Sea Link

**Document 9.65: Draft Statement of Common Ground Between National Grid Electricity Transmission and the National Trust.**

**Planning Inspectorate Reference: EN020026**

**Version: B  
March 2026**

# Appendix B

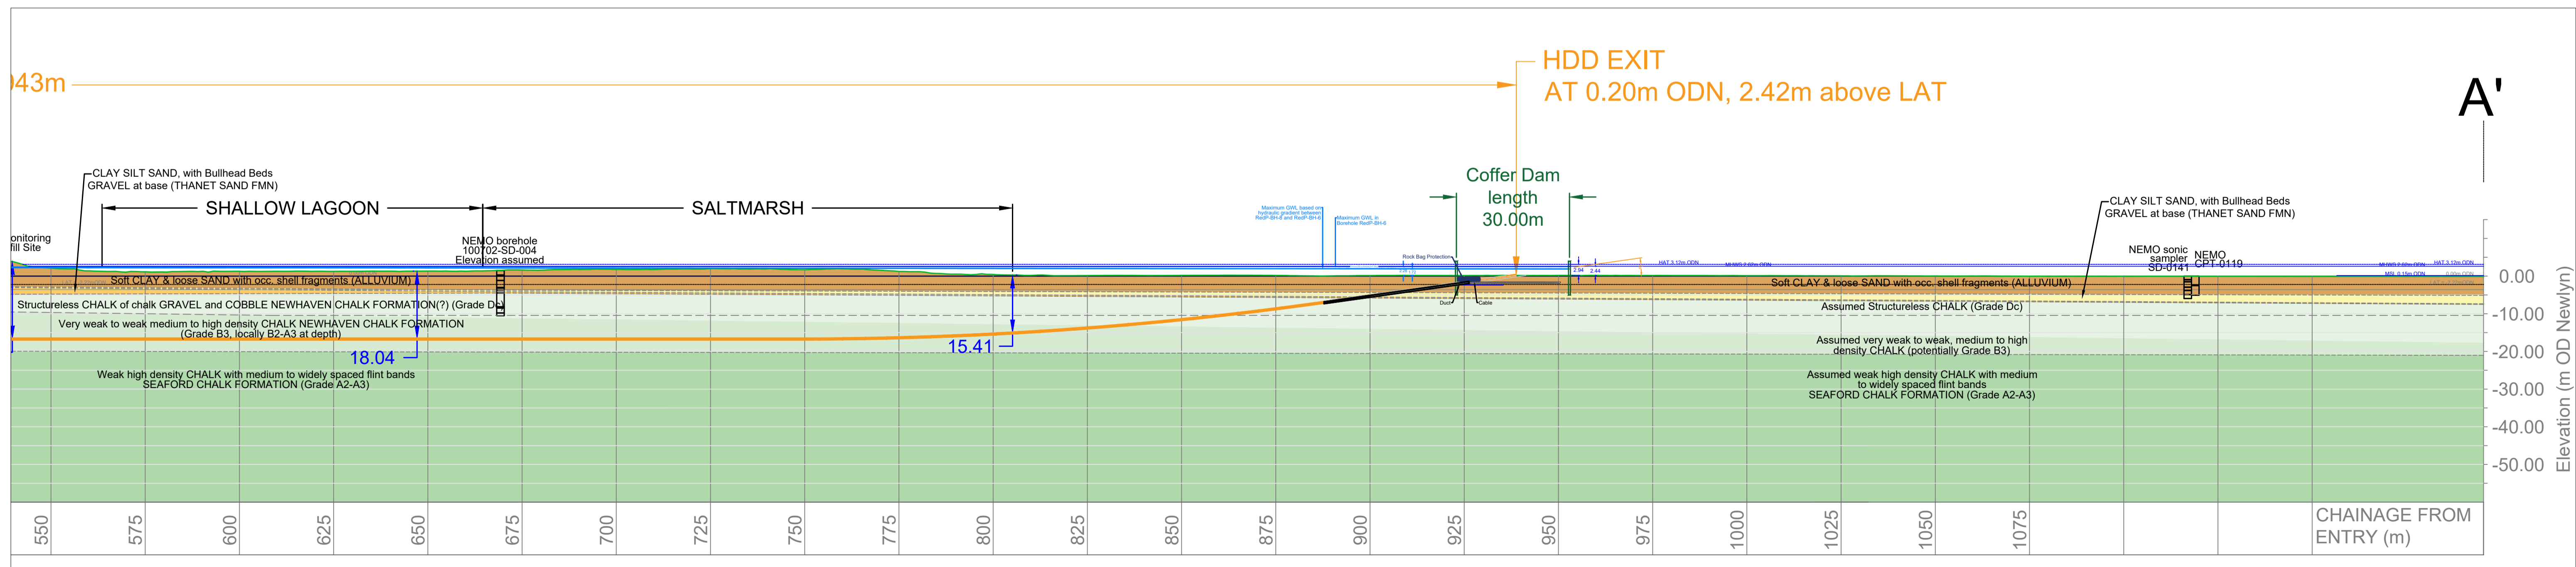
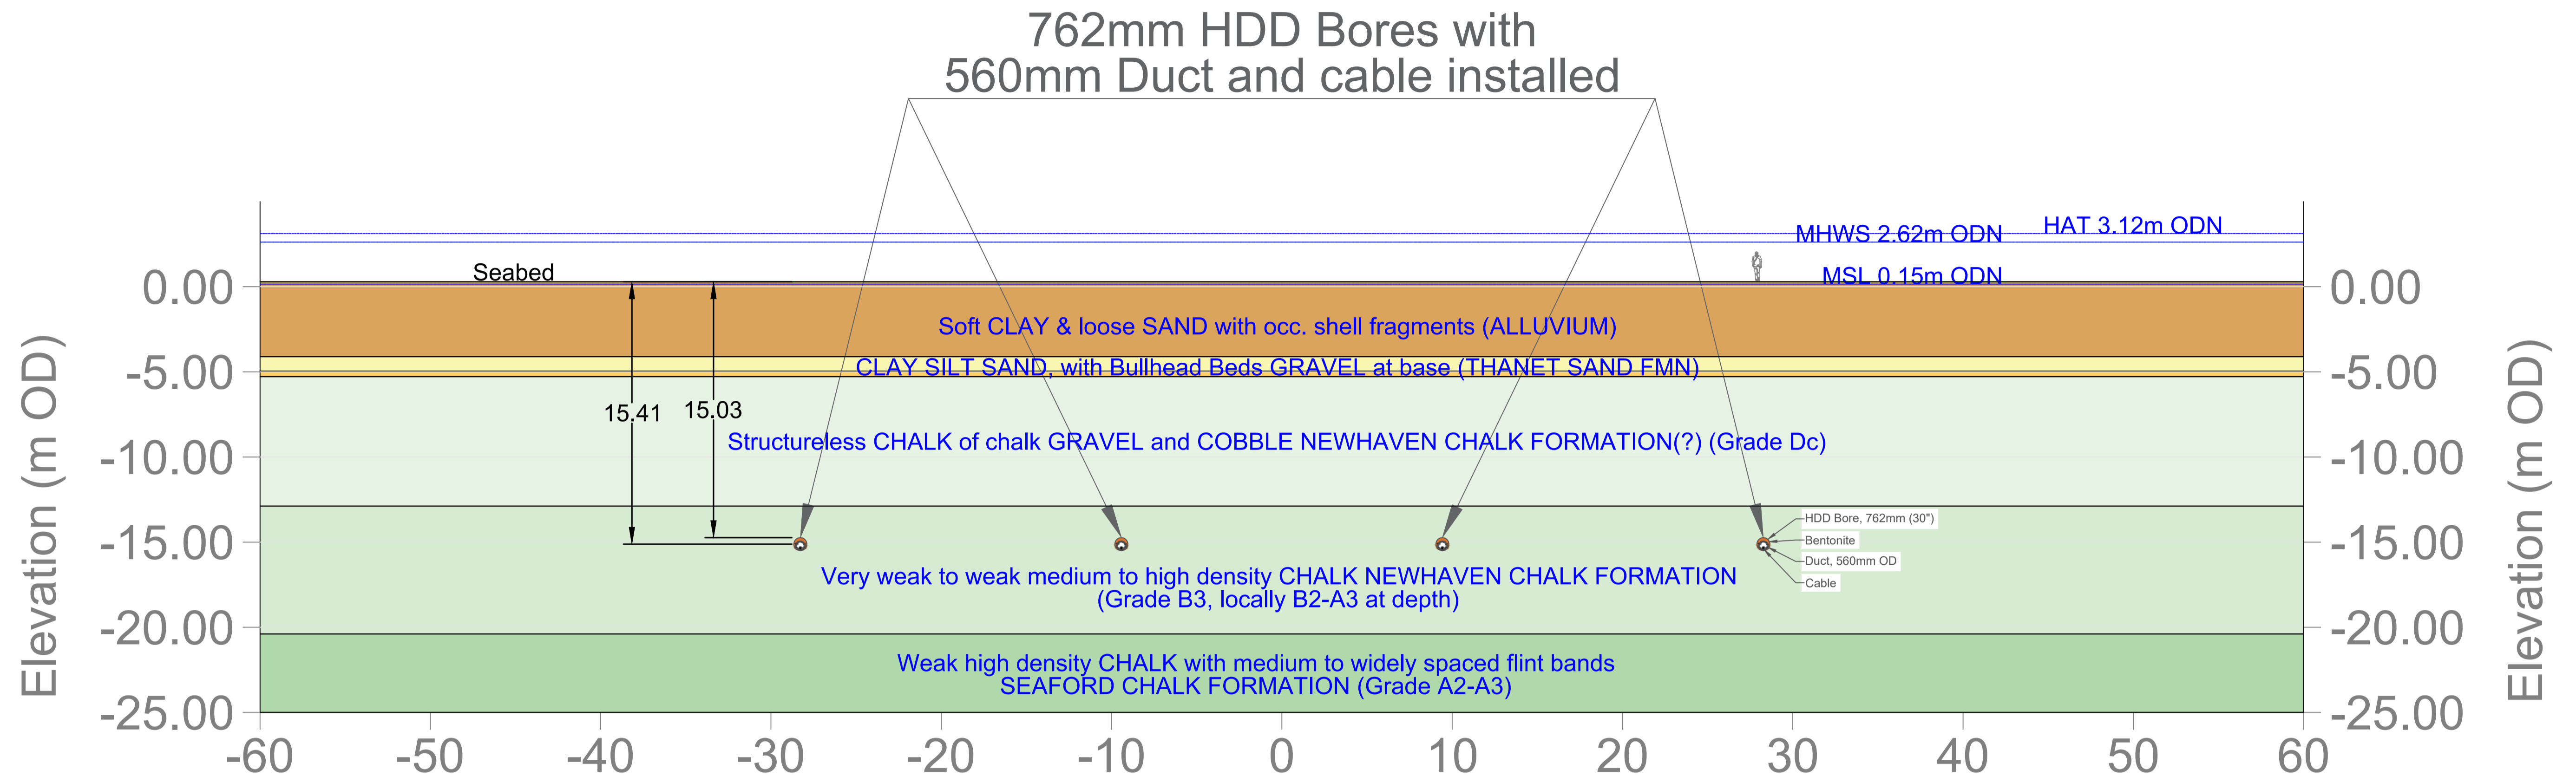
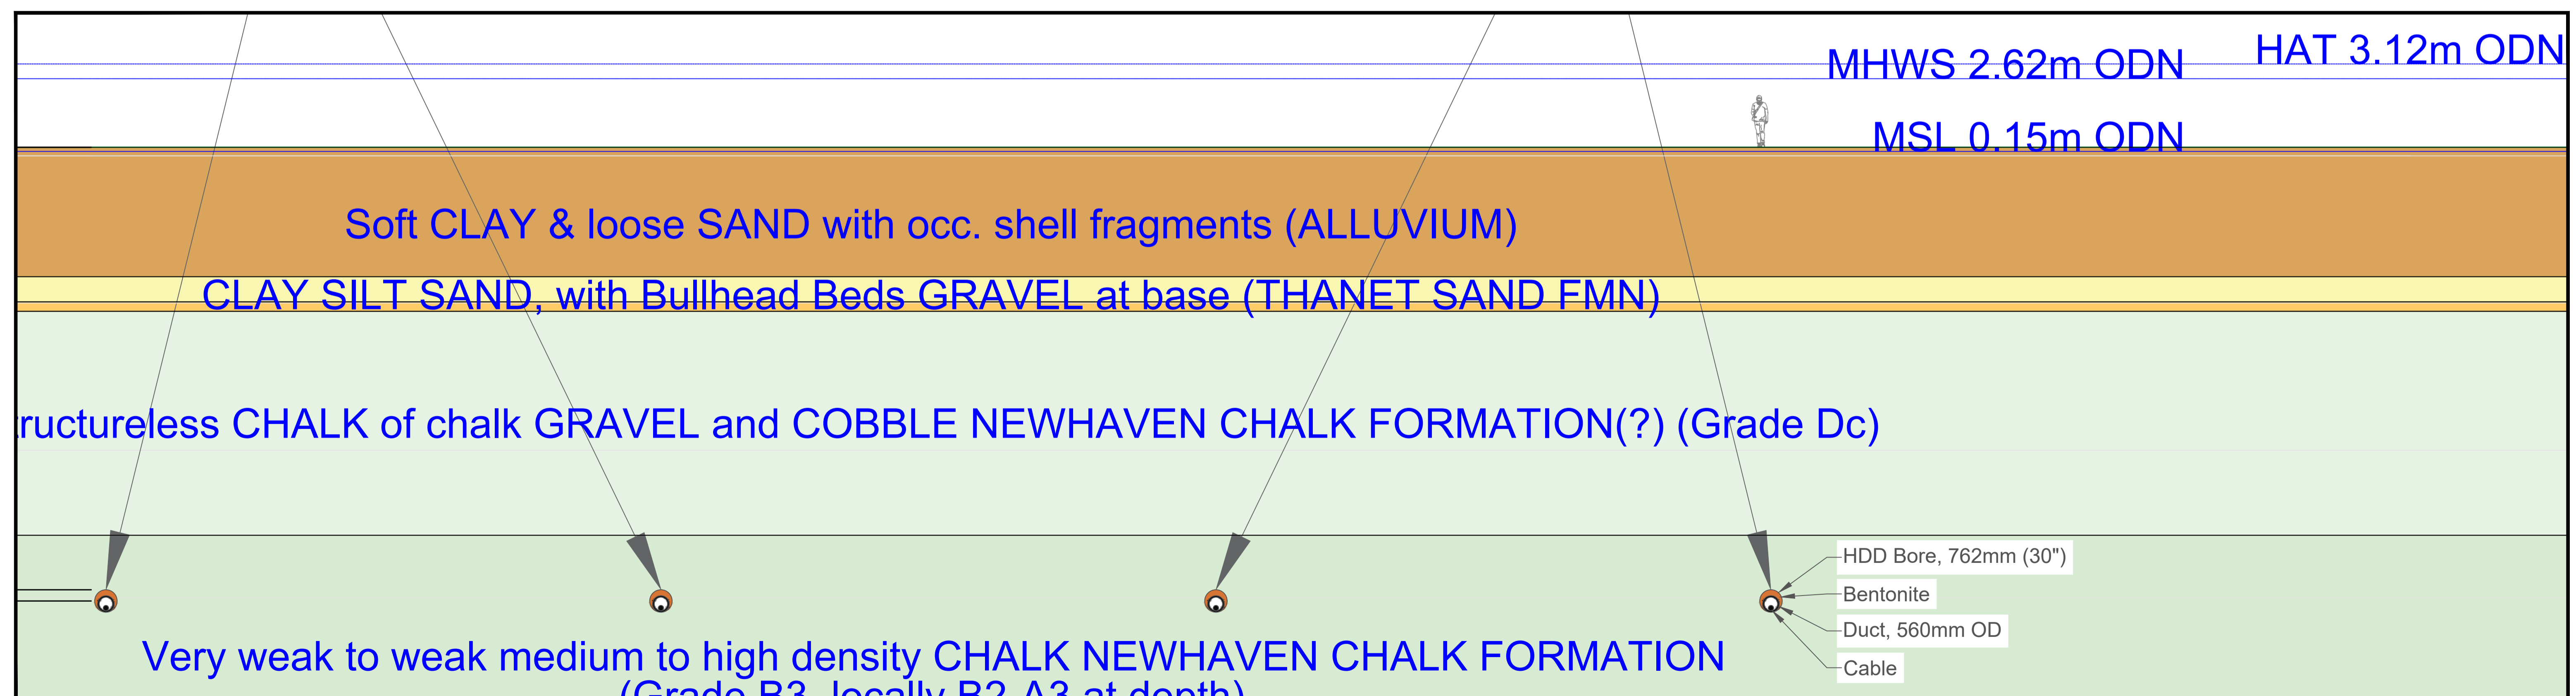
Ref	Relevant Application Documents	Description of Matter	Consultee's Current Position	The Applicant Current Position	Status
Chapter 2	Horizontal Direct Drilling (HDD) Impacts on Ecological designations on National Trust Land	<p>The National Trust does not object to the principle of the proposed offshore high voltage direct current link between Suffolk and Kent with onshore converter stations and connections back to the national electricity transmission system.</p> <p>We would support the developer's use of Horizontal Directional Drilling (HDD) construction methods at Pegwell Bay and would expect to see a firm commitment to undertake this form of engineering if this proves to be less detrimental than other alternatives. The entry point for the HDD is 470m west of the SAC/SPA/SSSI and Trust land. It is proposed to drill at 15-18m depth under the saltmarsh, and the exit point will be to the east of the saltmarsh in intertidal mudflat (Figure 6.4.4.2.4 Habitats present at, and location of, trenchless solution entry/exit points). However, the method statements do not rule out the need for trench installation if HDD proves to be difficult/impossible to use. If trenchless techniques are used, the Trust would have concerns due to the potential of the cumulative impacts on the Nature Reserve arising due to the possibility of the proliferation of cables installed previously for the Nemo link. Consequently, the Trust would want assurances that there will be nothing above ground on our land.</p> <p>The Trust welcomes the Applicant's confirmation. The Trust seeks in addition that the Applicant completes an HDD Management Plan after first consulting with the Trust and other relevant stakeholders.</p>	<p>The current draft DCO prohibits cable installation in Pegwell Bay using techniques that are not trenchless to cross the sensitive saltmarsh. If other than a trenchless technique were proposed at this location, any proposals for alternative methods would require a formal amendment to the DCO and would need to be supported by an additional environmental assessment.</p> <p>However, as outlined in <b>Application Document 7.3 Design Development Report – Appendix A Landfall HDD Feasibility Technical Note [APP-321]</b>, ground investigations have confirmed suitable drilling conditions for HDD. The report states that initial hydrofracture modelling, using ground strength parameters from the ground investigations, shows a 2.8 factor of safety against frac out. This means that the drilling fluid pressure would need to be 2.8 times the pressure required to drill through the formation, to cause a surface frac out in the SSSI. Therefore, there is a very low risk of frac out.</p> <p>The Applicant can confirm that the HDD contractor will produce a detailed, drilling fluid management plan to be approved by the MMO in consultation with relevant stakeholders including Natural England, that includes drilling fluid breakout mitigation measures, where HDD is proposed. This is currently secured within the Deemed Marine Licence through <b>Application Document 9.92 (A) Outline Cable Specification and Installation Plan [REP4-090]</b> submitted at Deadline 4, <b>Application Document 7.5.2 (B) Outline Offshore Construction Environmental Management Plan [REP4-223]</b>, and also within <b>Application Document 9.84 (B) Register of Environmental Actions and Commitments [REP4-234]</b> under <b>B59</b>.</p> <p>In addition to the above, a HDD Landfall Method Statement will be developed following detailed design which is currently secured within the Deemed Marine Licence through <b>Application Document 7.5.2 (A) Outline Offshore Construction Environmental Management Plan [APP-339]</b>. The National Trust will be consulted on this document.</p> <p>A list of relevant securing mechanisms for the Proposed Project is provided in Appendix A. In addition to this, a cross sectional image</p>	Under discussion
